ATTACHMENT FOUR

PROPOSED TECHNICAL SPECIFICATION REVISIONS

ATTACHMENT FIVE

FSAR MARK-UPS

III. Sprayed Fluid - Recirculation Phase

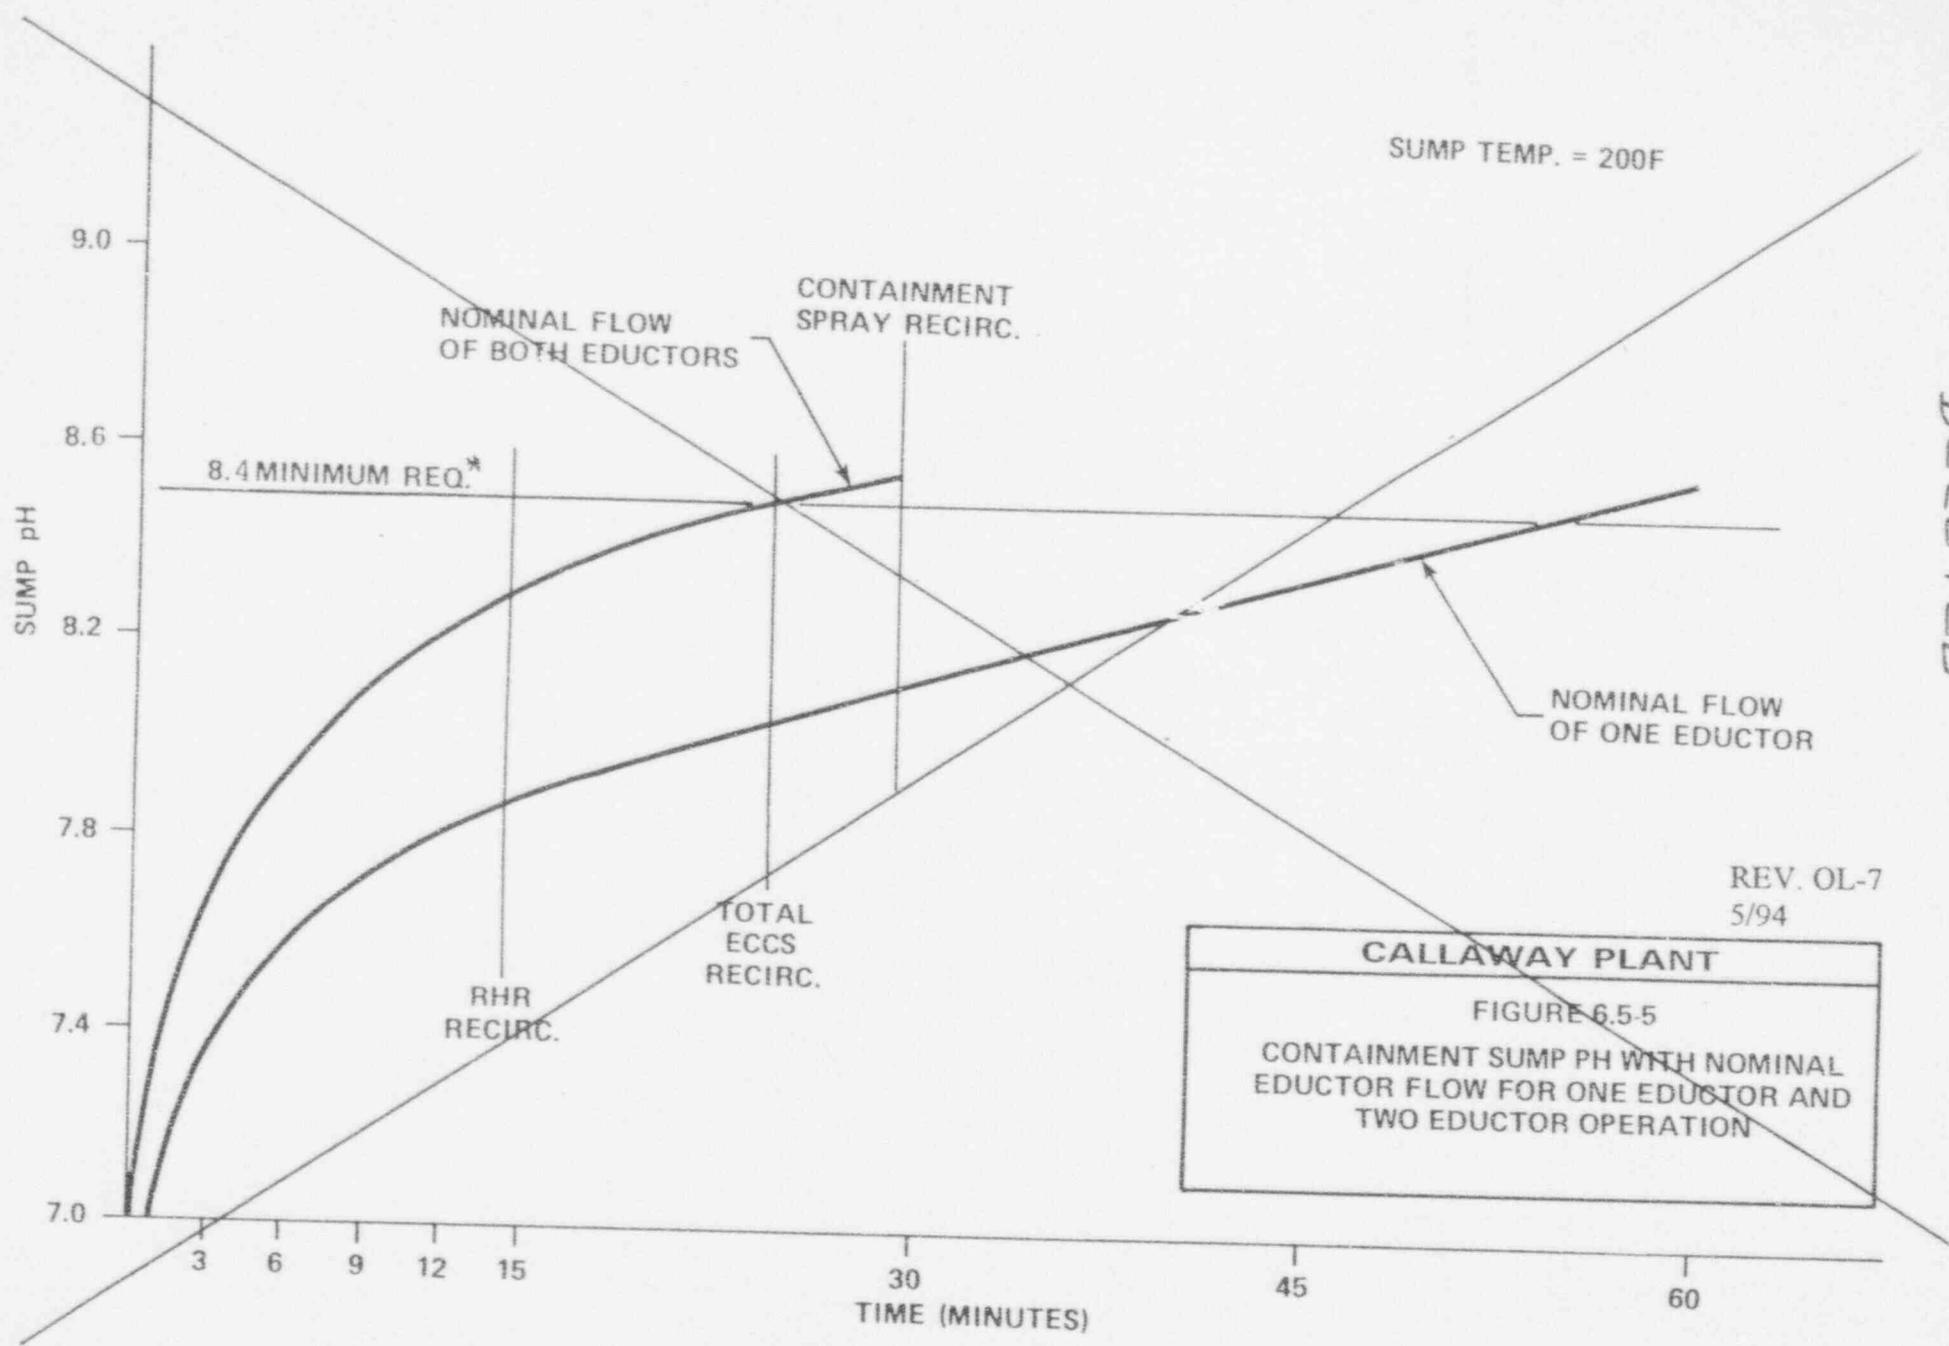
~~4.0-11.0~~ - 7.0
 4.0
 100
 100
 2,500/2,350
~~0-7,530~~
 37-120

~~8.0-11.0~~ 7.1-11.0
 2,500/~~1,900~~ 2,007
~~10,300~~
 120-255
